Application No. A/NE-TKL/837

Section 16 Planning Application for Temporary Open Storage of Recycling Materials and Metalware with Ancillary Facilities and Associated Filling of Land for a Period of 3 Years at Lots 86 (Part), 87 and 89 in D.D. 83 and Adjoining Government Land, Kwan Tei North, Fanling, New Territories

Submission of Further Information 2

Responses to Departmental Comments

Swept Path Analysis

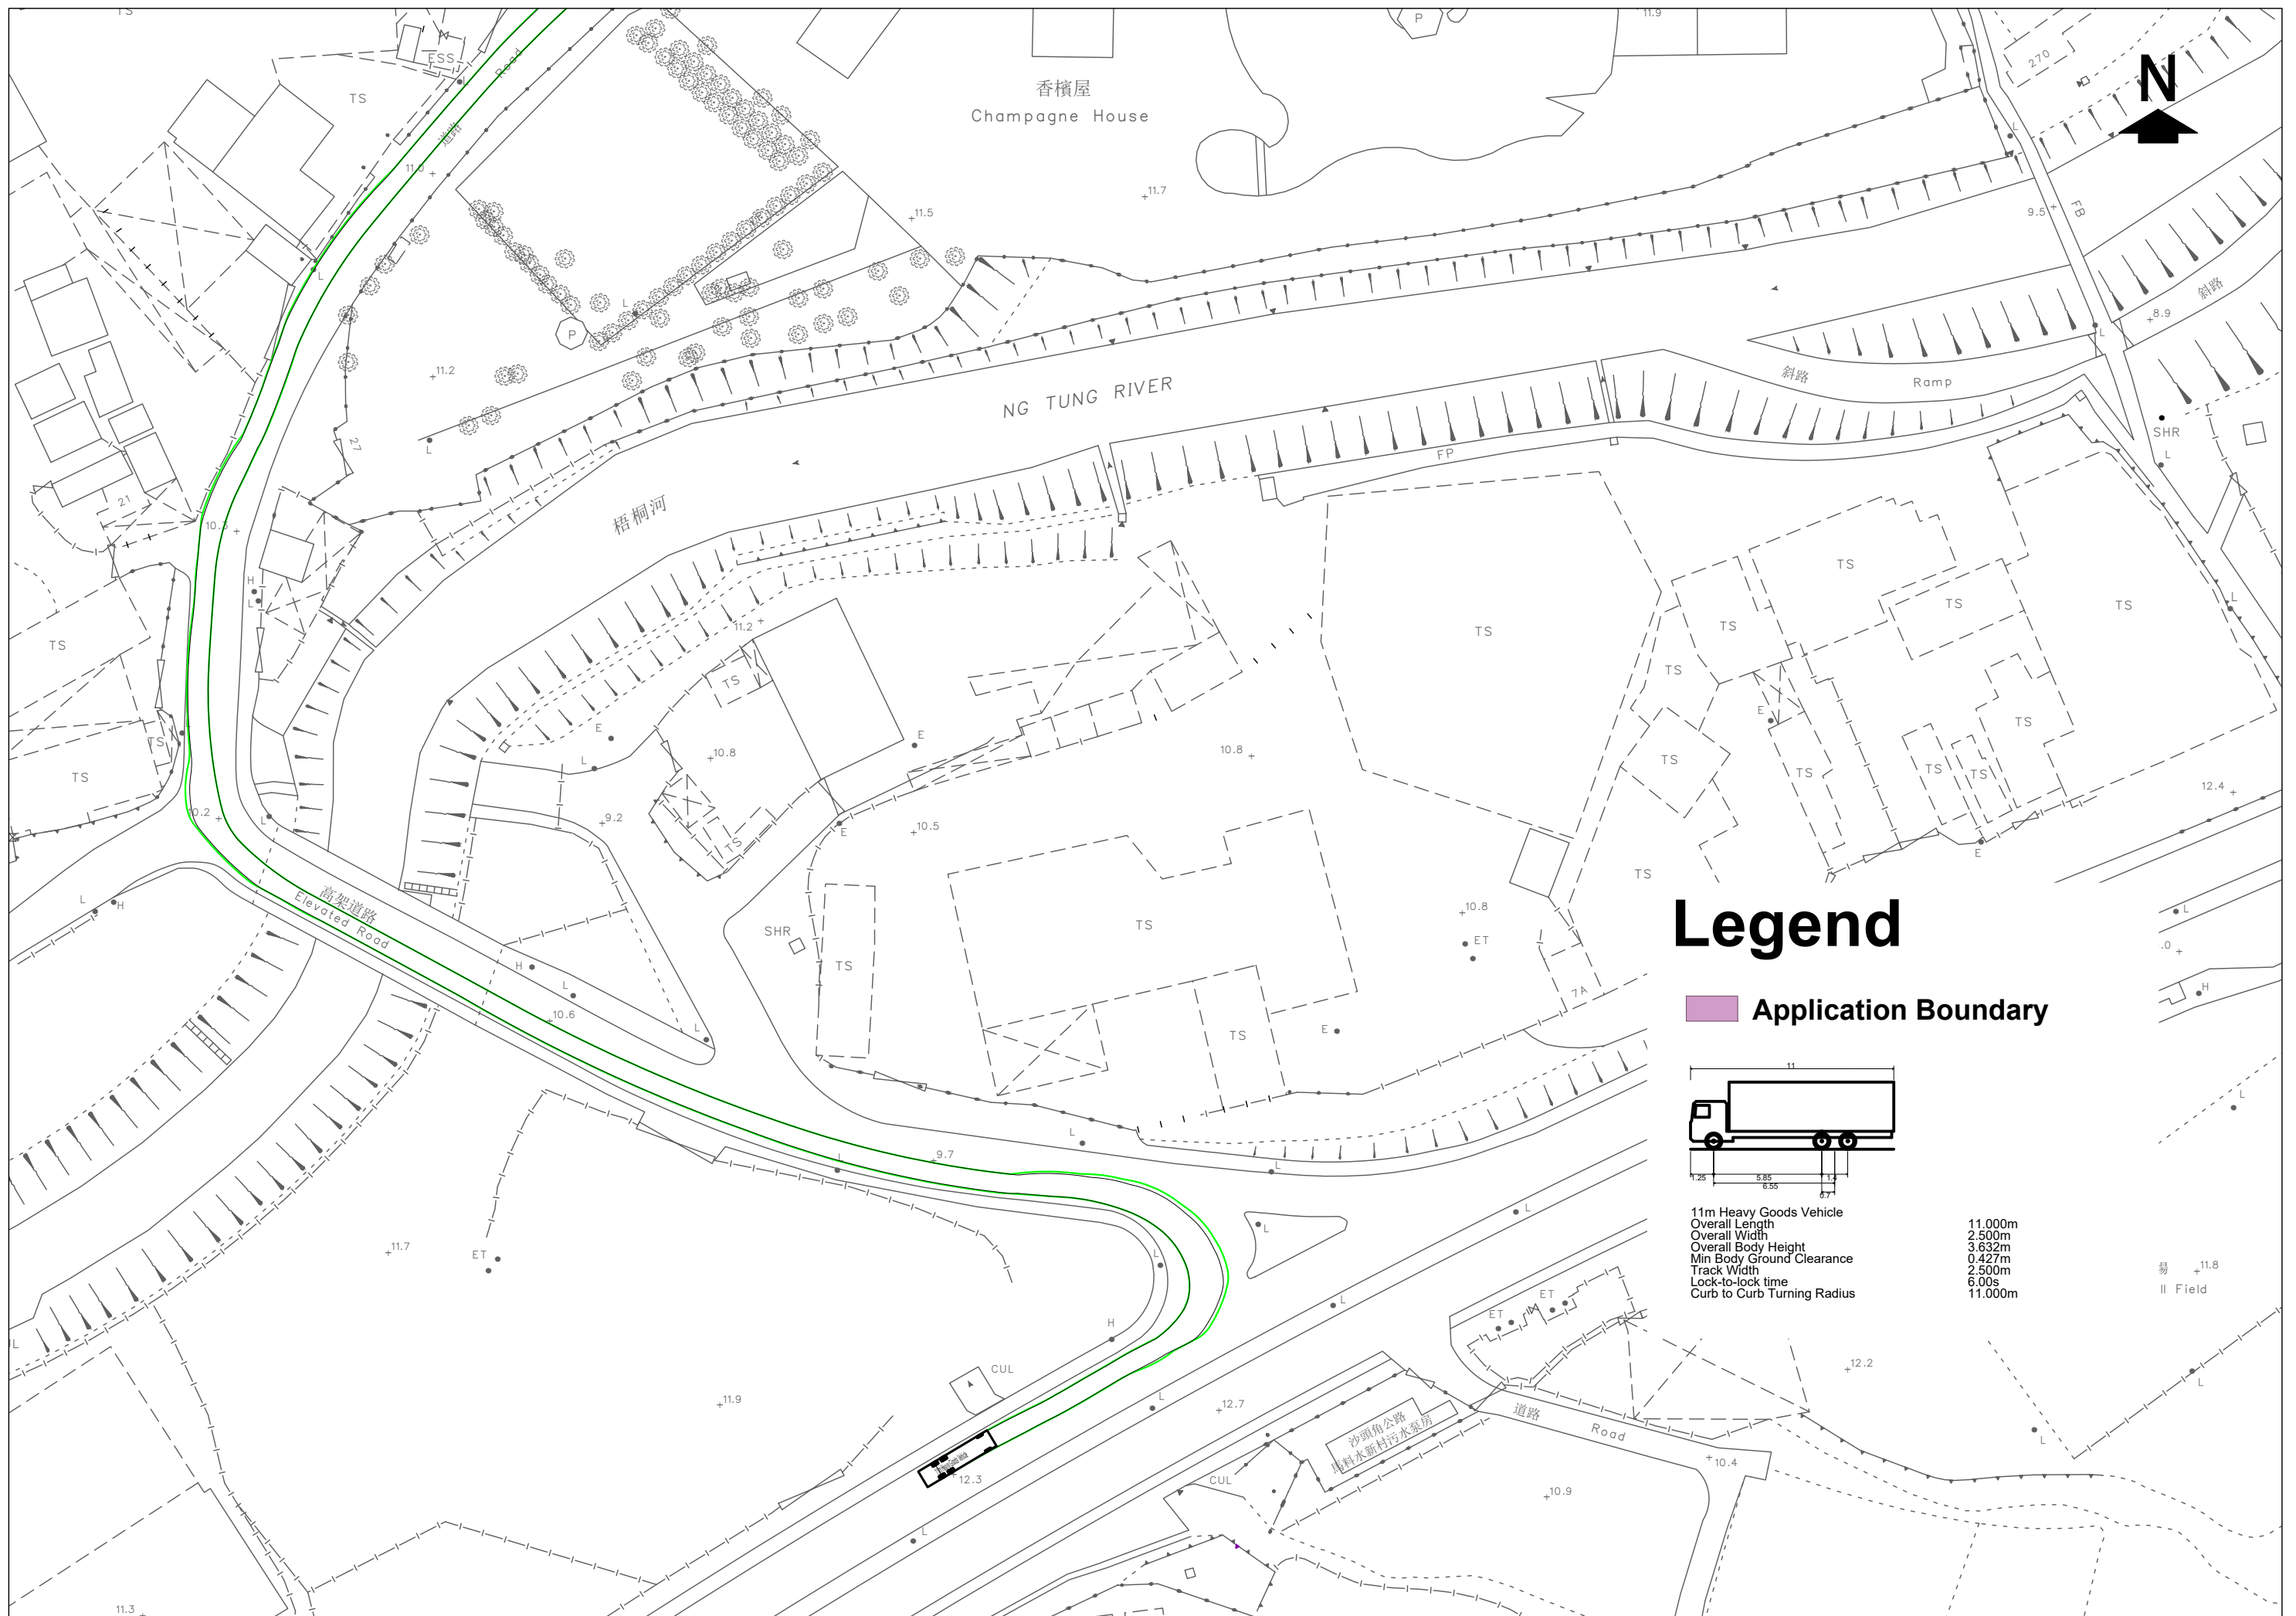
Item	Departmental Comments	Applicant's Responses
1. Comments from Transport Department received on 18.5.2026		
	- the dimension of good vehicles used for swept path analysis should follow the table 5.4.4.1 in Volume 7 of TPDM; and - the applicant should propose measures, such as installation of traffic warning signs and provision of passing bays, to ensure that the movement of site vehicles will not clash with the vehicles riding in opposite direction along the access road linking Sha Tau Kok Road - Lung Yuek Tau to the application site.	The revised swept path analysis is attached at Annex 1 of this FI submission. Please refer to Annex 2 for the proposed traffic warning signs along the access road, which are located on Government land. Upon approval of the application, the Applicant will apply to the relevant departments for permission for the installation of the signage.

Land Filling Plan

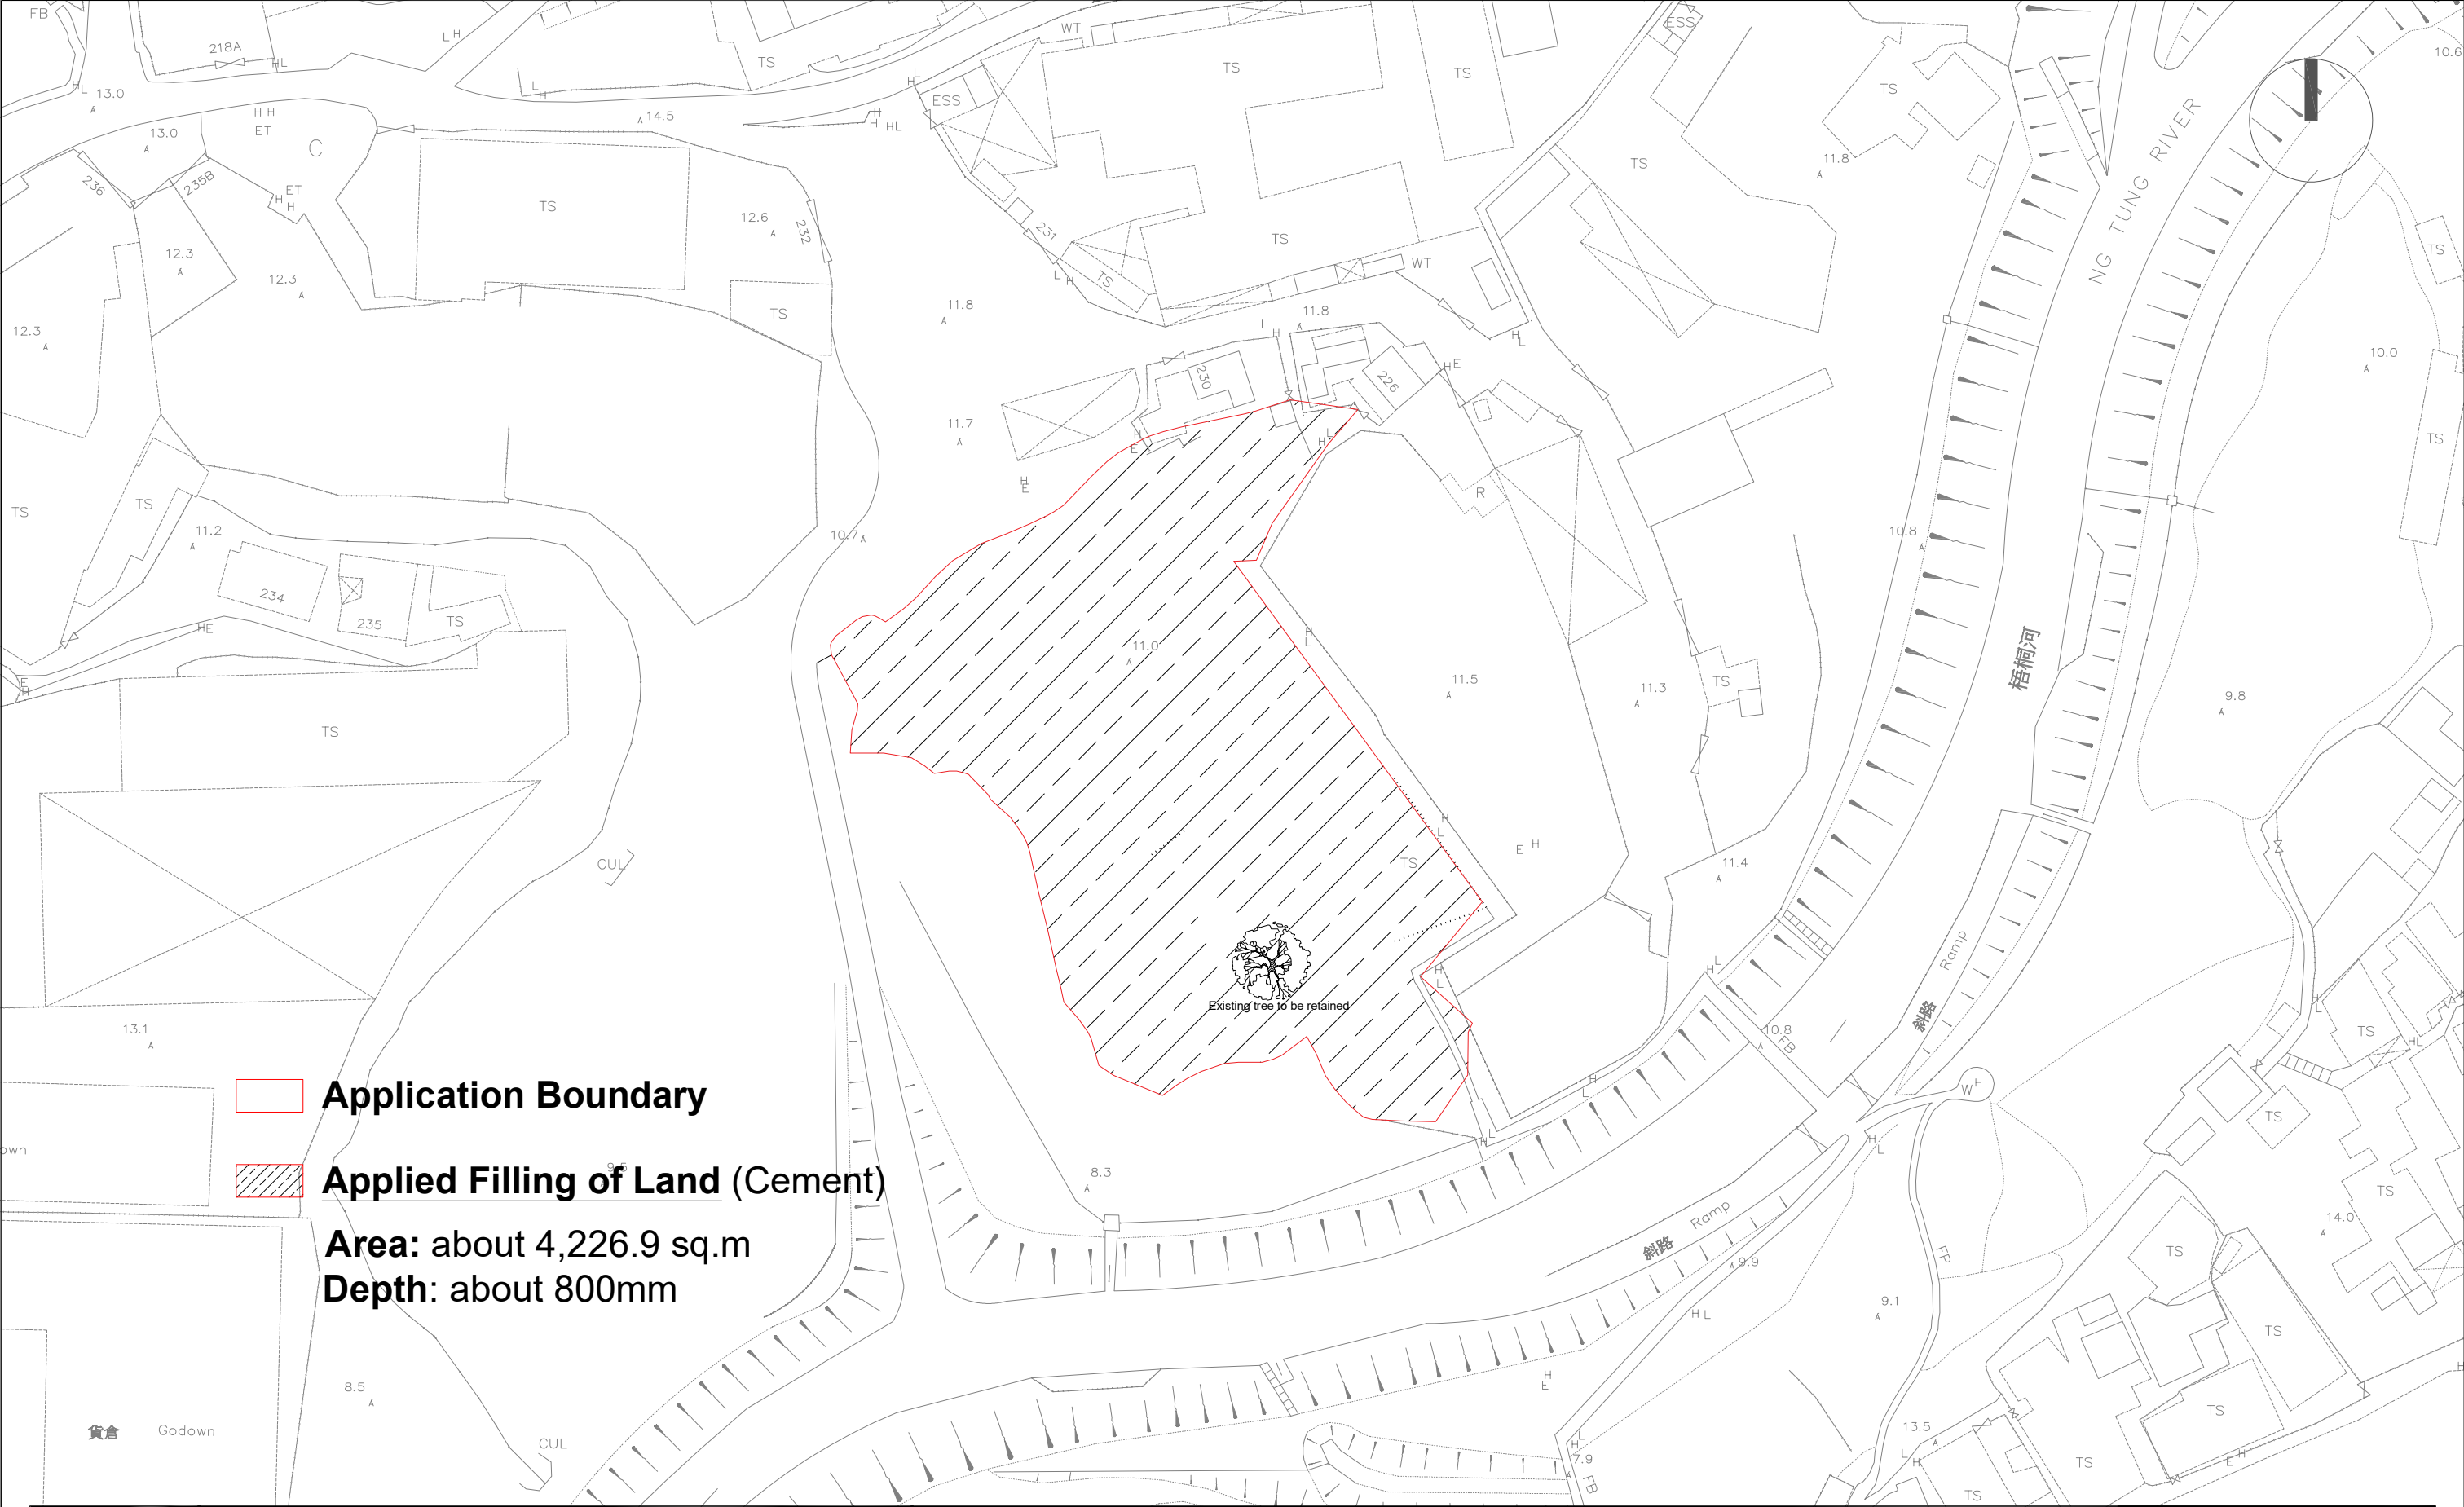
2. Comments from Planning Department received on 4.5.2026		
	As discussed previously, please also provide supplementary information on the filling of land at the application site.	Please be informed that the Application Site had already been paved prior to the Applicant's tenancy of the site. It is understood that the earlier filling of land was primarily carried out for site formation purposes for open storage use. The current applied filling of land is intended to regularise the previously filled area and reflect the present conditions of the Application Site. Accordingly, there will be no further filling of land in the future. The applied filling of land comprises approximately 4,226.9m² with a depth of 800mm. Please refer to Annex 3 for the land filling plan. At present, the highest level of the Application Site is about 11.4mPD, while the lowest level is approximately 9.7mPD. The site levels prior to land filling are estimated to range from about 8.9mPD to 10.6mPD.
